SECTION 009113 – ADDENDUM TWO

- A. Project Name: 22034.02 Meridian High School Additions, Renovations and Ballfield Rebid
- B. Owner: Meridian Public School District, 1019 25th Avenue, Meridian, MS 38391
- C. Architect: Dale | Bailey, an Association, One Jackson Place, Suite 250, 188 East Capitol Street, Jackson, MS 39201-2100
- D. Architect Project Number: 22034.02
- E. Date of Addendum Two: 12 January 2024

1 Typical Accessory Mounting Heights
3/8" = 1'-0"

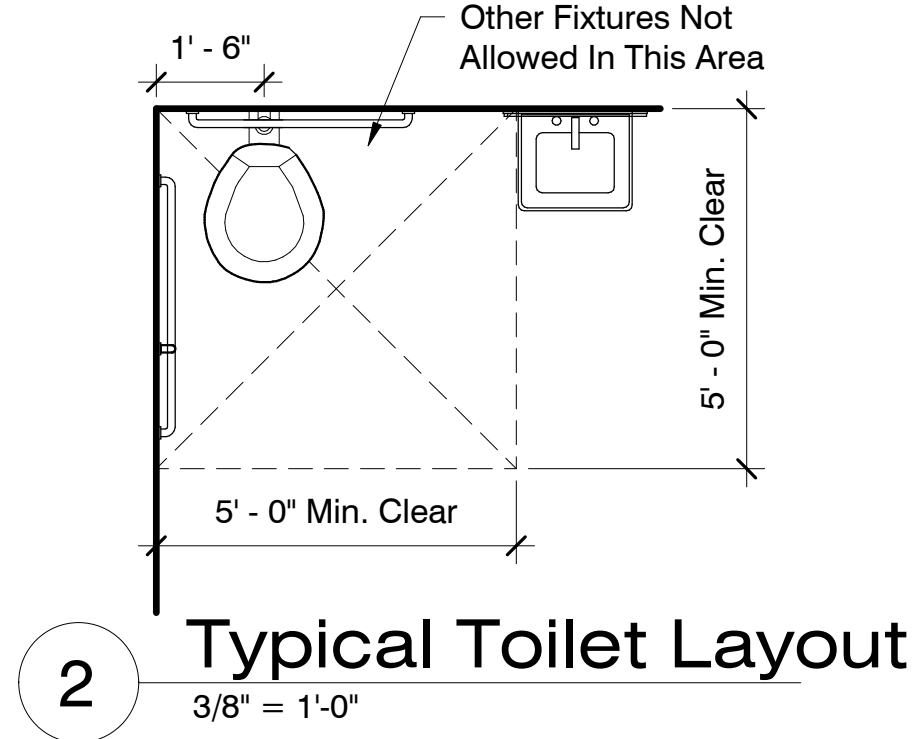
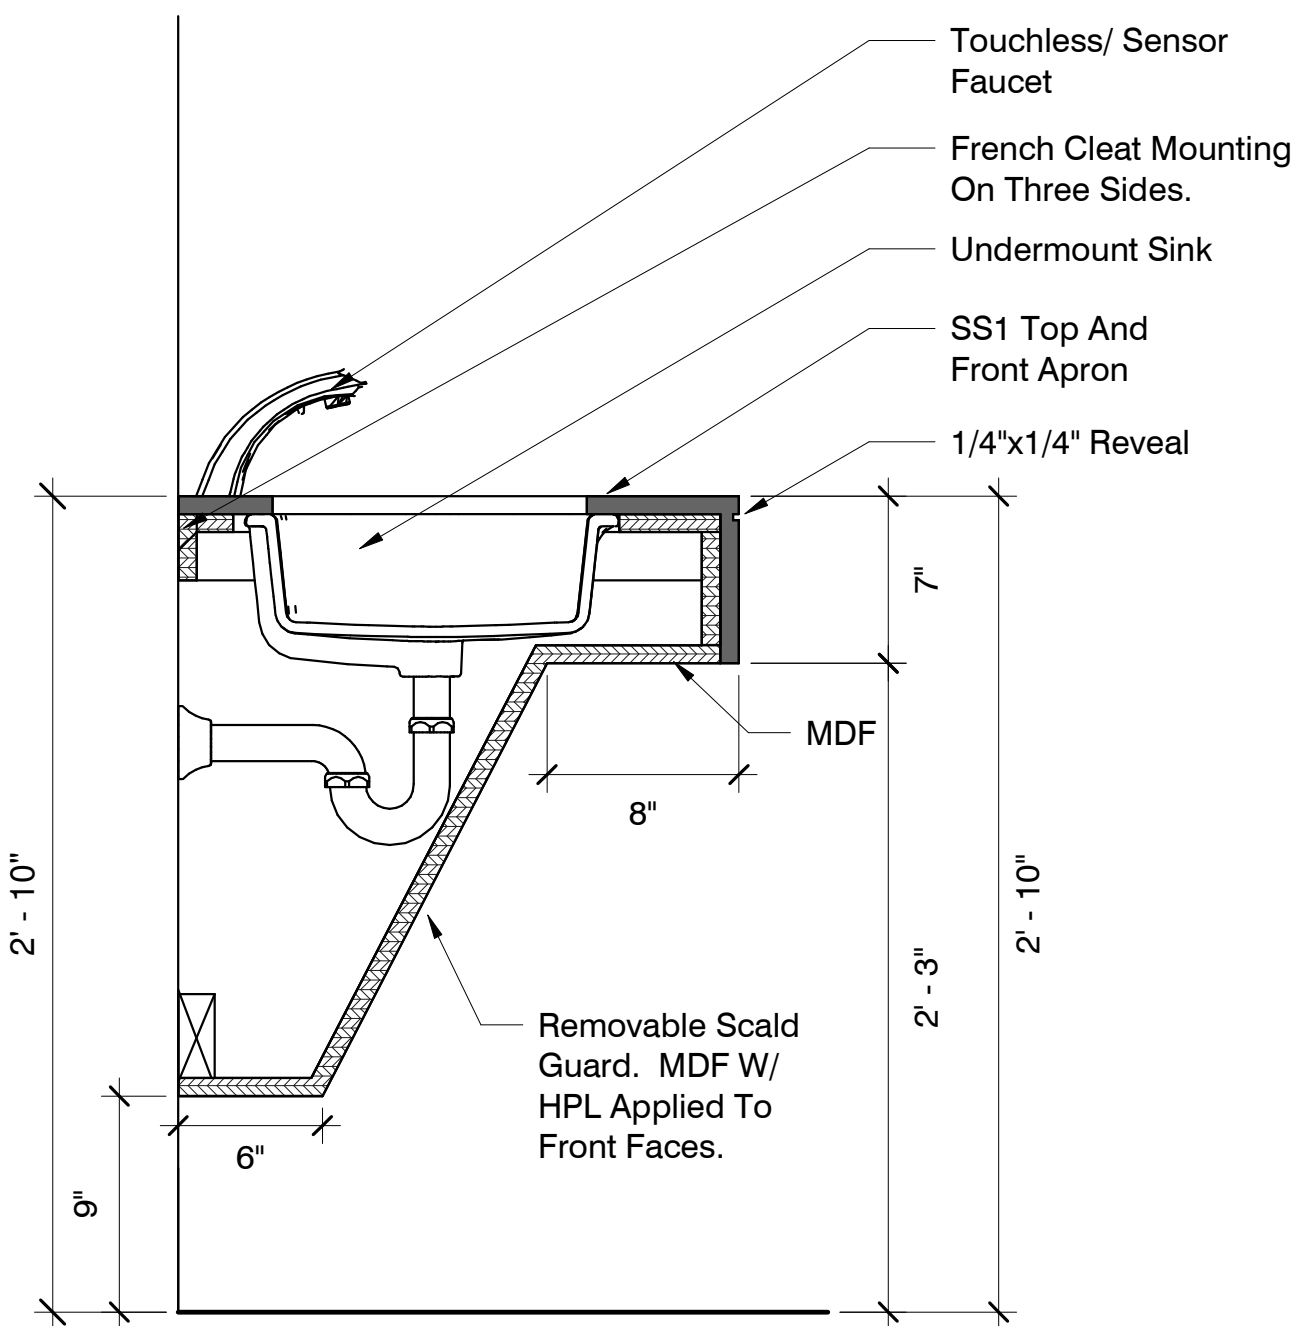
- A. Sheet AS101 – Architectural Site Layout (Revised). Added guard shack location and awning brick detail.
- B. Sheet A-491 – Restroom Details (Revised). Added quantities to toilet accessories..
- C. Sheet RC101 – Site Layout & Access (Revised). Corrected print issue and added clear temporary fencing layout for project.
- D. Sheet E-004A – Electrical Renovation Site Plan (Revised). Added power for modular building.
- E. Sheet E-201B – Overall Power Plan (Revised). Deleted power for modular building.

1 Site Plan Layout
1/64" = 1'-0"

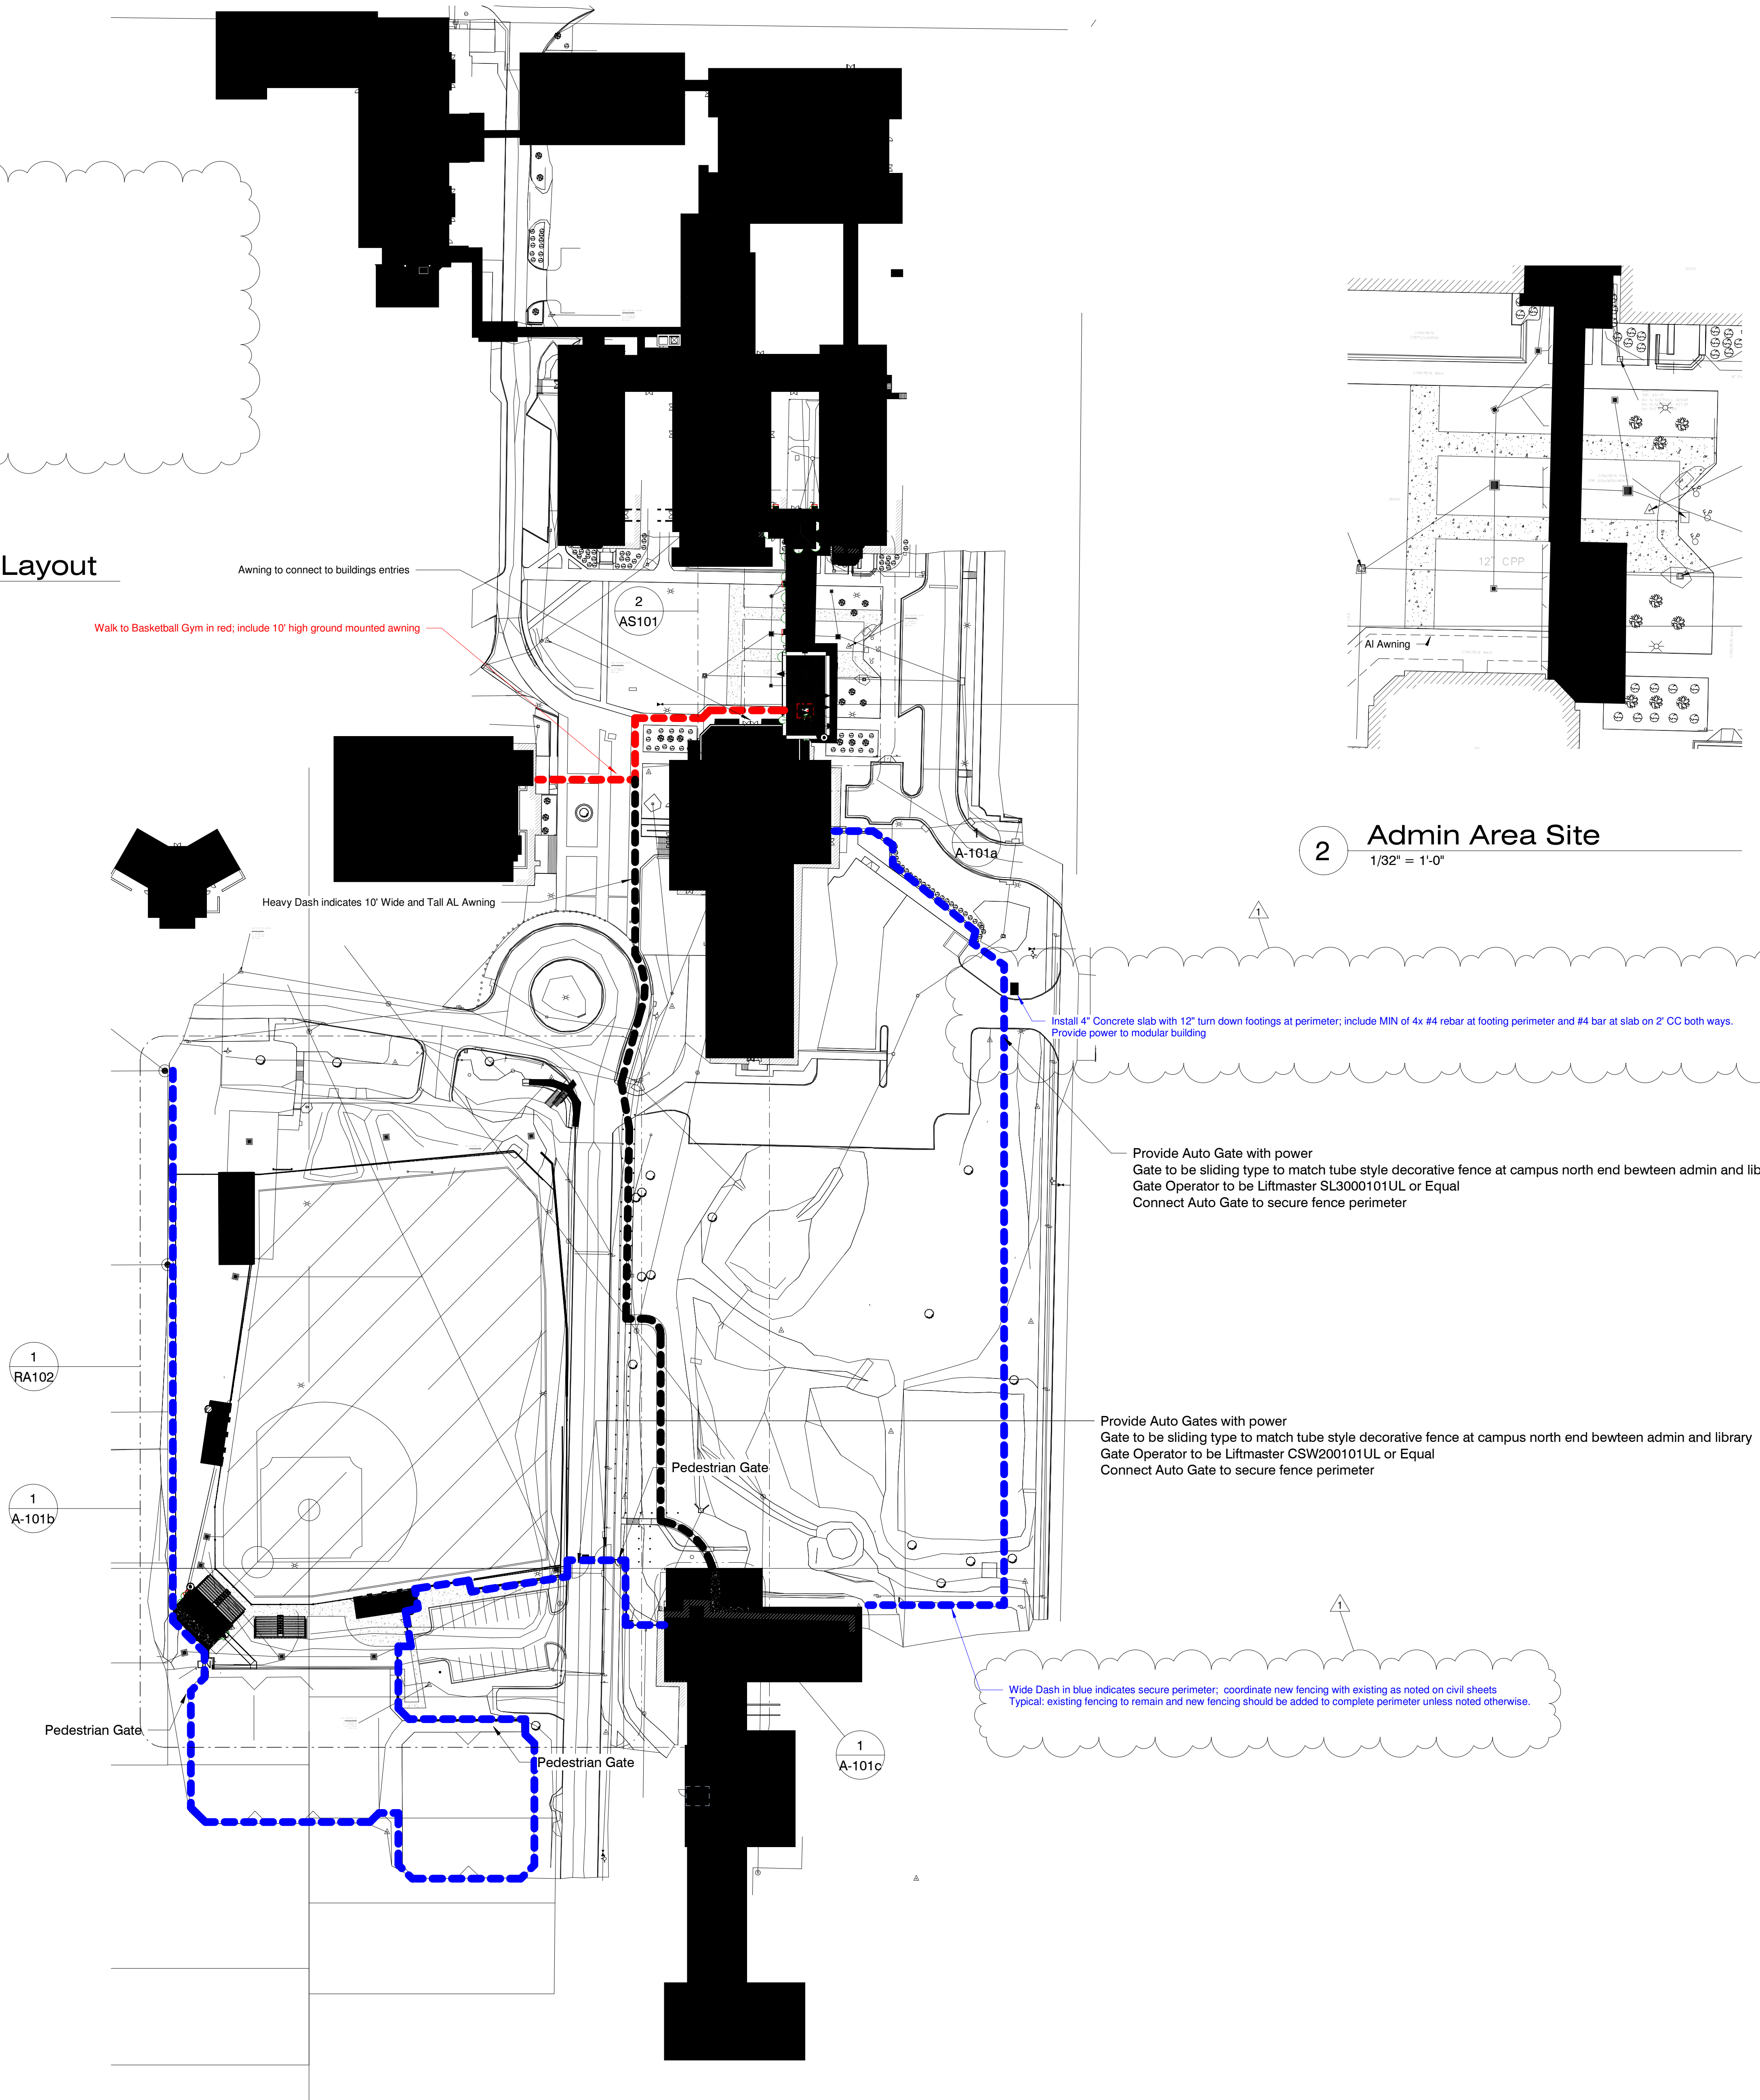
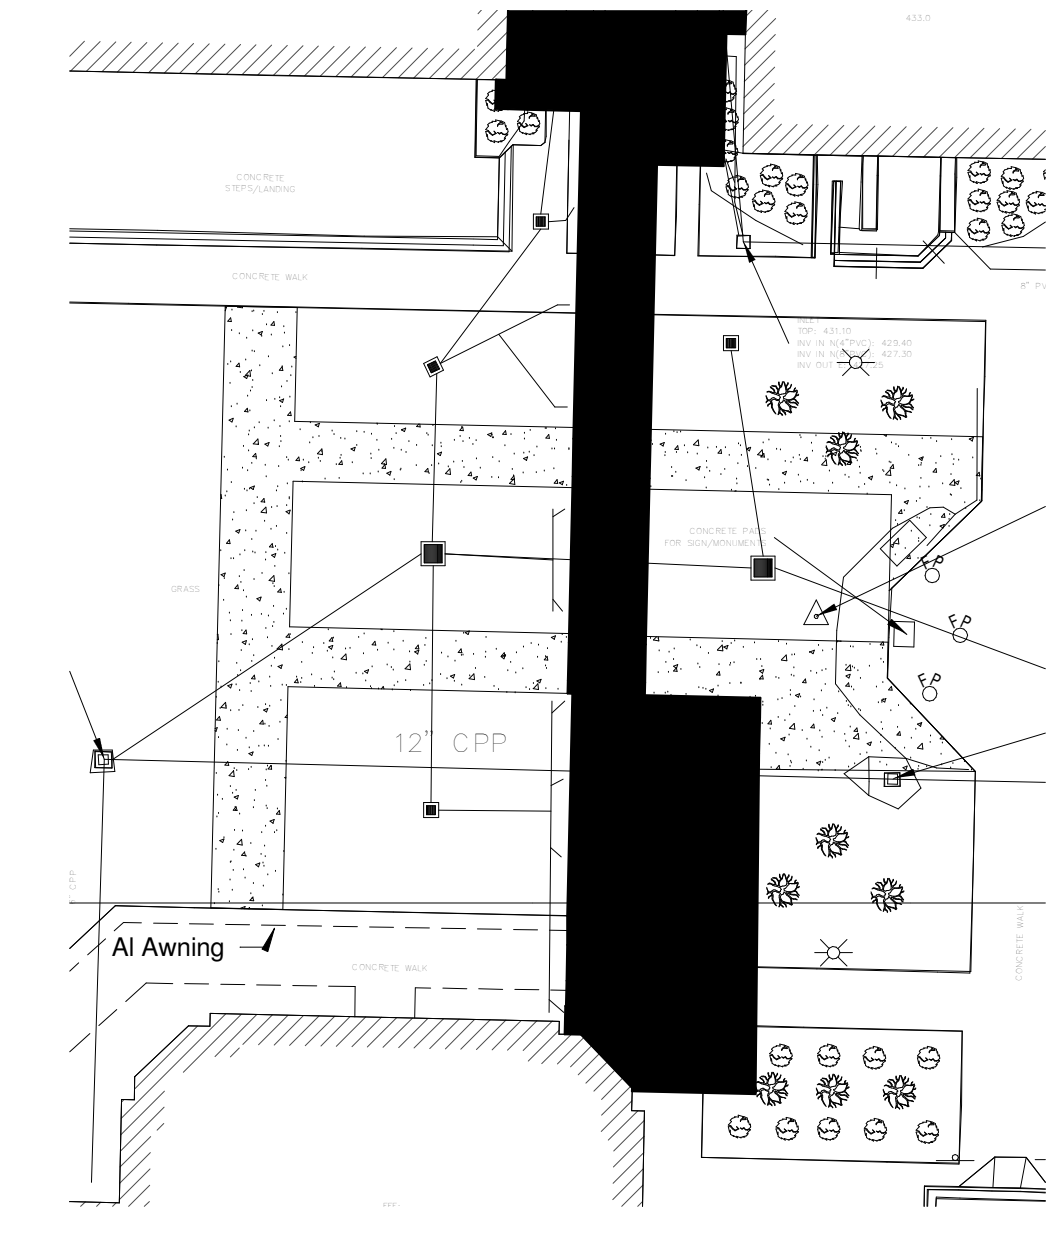
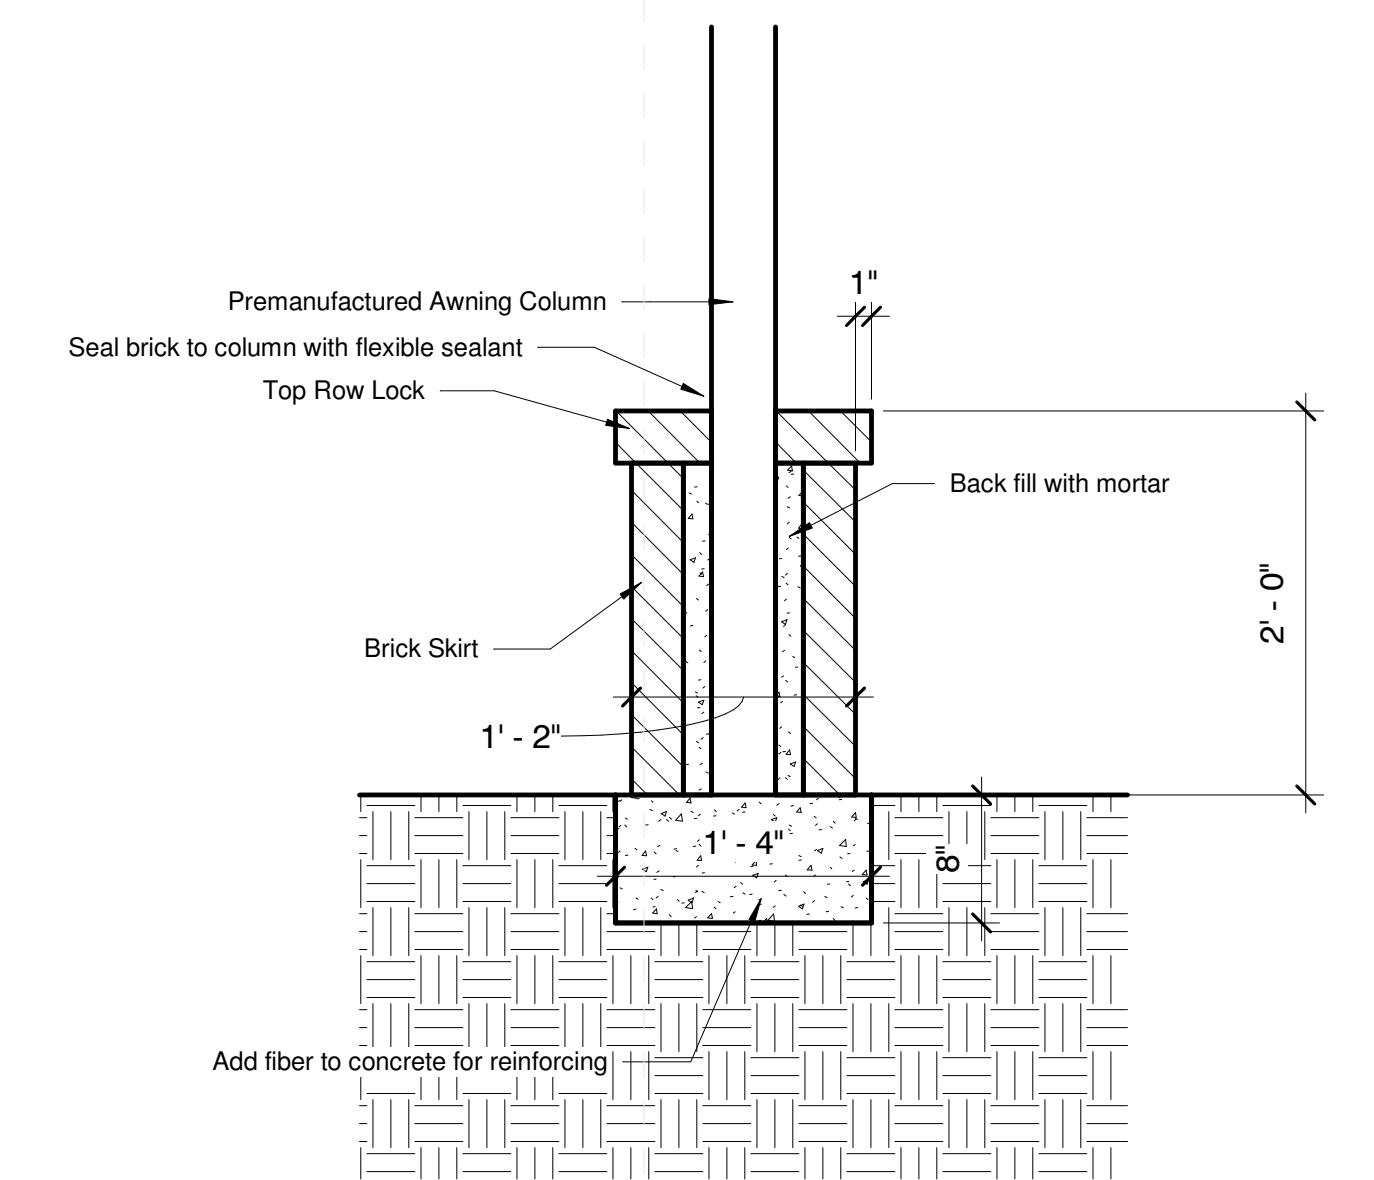
- D. QUESTION: AS101 shows canopies leading from Ross Collins and the gym. Are there any details of these canopies? Also, the descriptions in the upper left corner of the page of the colored lines do not match the notes on the lines.

ANSWER: The design of this awning is delegated to the manufacturer provided that it meets the base requirements of the specifications and drawings. The Contractor is encouraged to visit the site so that they may be familiar with the variety of conditions they will encounter.
